AP1000 DESIGN CERTIFICATION REVIEW

Response to Request For Additional Information

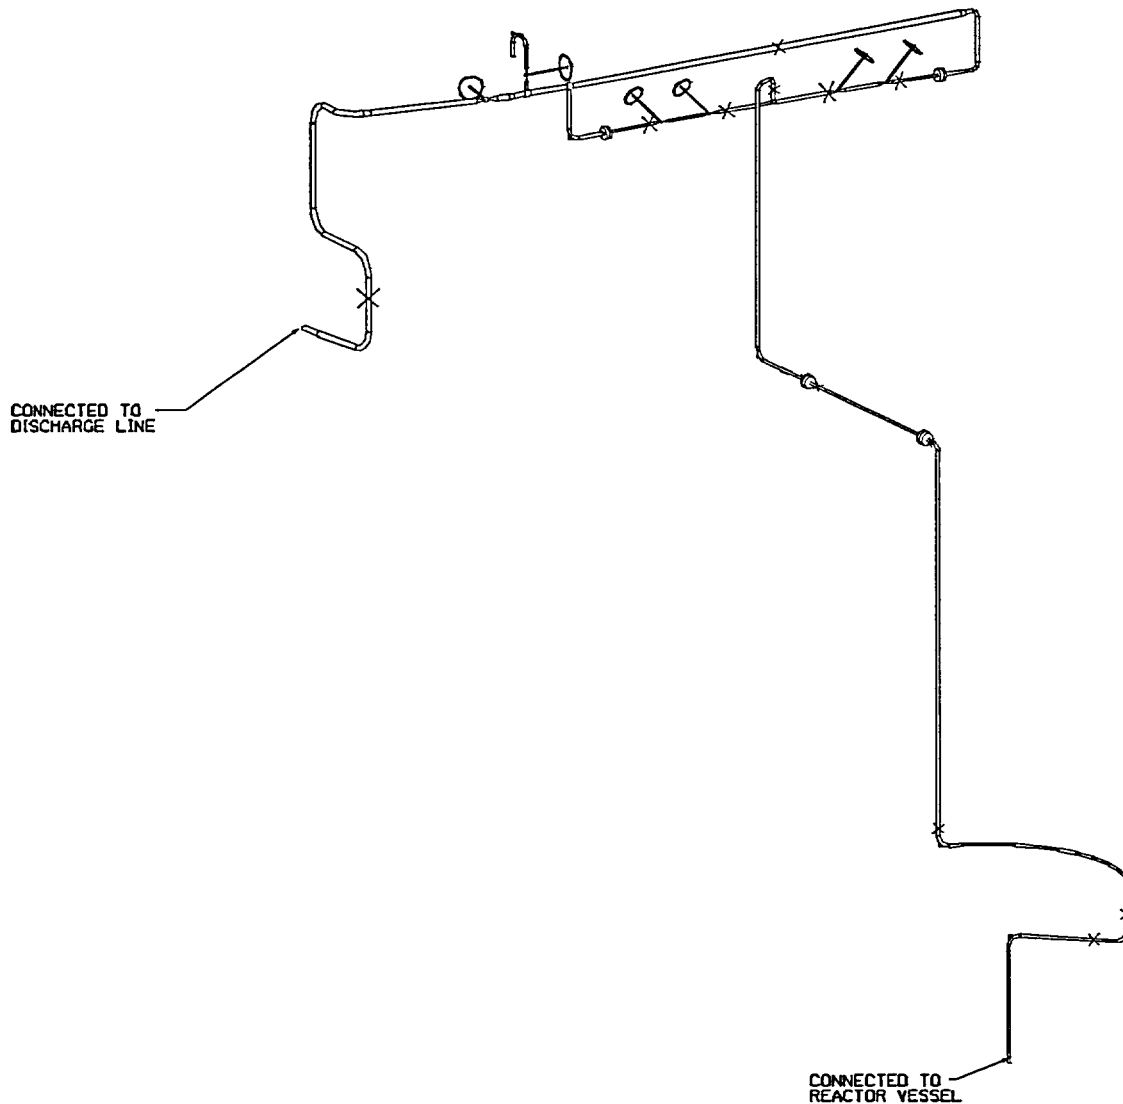
Hydrodynamic loads could be significant for piping systems with fast opening and closing valves. The reactor vessel head vent system (RVHVS) piping has been identified as a system susceptible to such large hydraulic transient loadings. Experience from operating nuclear power plants indicates that thermal hydraulic loads could be very severe for certain operating modes if the piping layout does not take this aspect into careful consideration. Please provide assurance that the AP1000 plant specific RVHVS piping configuration can be designed to withstand the transient thrust forces caused by the valve opening without performing the thermal hydraulic and structural dynamic analyses at this time. To demonstrate the conceptual design and facilitate the staff's review, it is suggested that a sketch be provided along with the response.

The reactor vessel head vent piping systems (RVHVS) utilized in conventional Westinghouse PWRs consist of two basic layout configuration types. One layout configuration utilizes a modified CRDM housing that is capped at the top and a one inch pipe welded to it. The flow path from which the RPV venting would occur is through the modified CRDM (approximately equivalent to a three inch pipe), into the one inch head vent piping containing the one inch valves, and discharging into either the containment or the discharge header of the Pressurizer Safety and Relief Valve System. This layout configuration can result in significant thermal hydraulic loads (upwards of 30 to 40 kips) due to RPV through the modified CRDM and into the one inch piping.

The second layout configuration type utilizes a one inch vent pipe welded to a dedicated one-inch penetration nozzle in the head of the RPV. For this layout configuration, the flow path for the venting is directly from the RPV into the one inch piping, through the one inch valves, and into either the containment or the PSARV discharge piping. This layout configuration significantly reduces the magnitude of the thermal hydraulic loads resulting from the venting of the RPV.

For both the AP600 and AP1000 RVHVS, the piping layout was developed such that the thermal hydraulic loads are kept to a minimum. The second layout configuration type as described above is utilized with the one inch piping welded directly to the RPV head. In addition, length of piping between elbows is also kept to a minimum in order to reduce the effect of these thermal hydraulic loadings. Long straight sections of piping (i.e. greater than 20 feet) are not used.
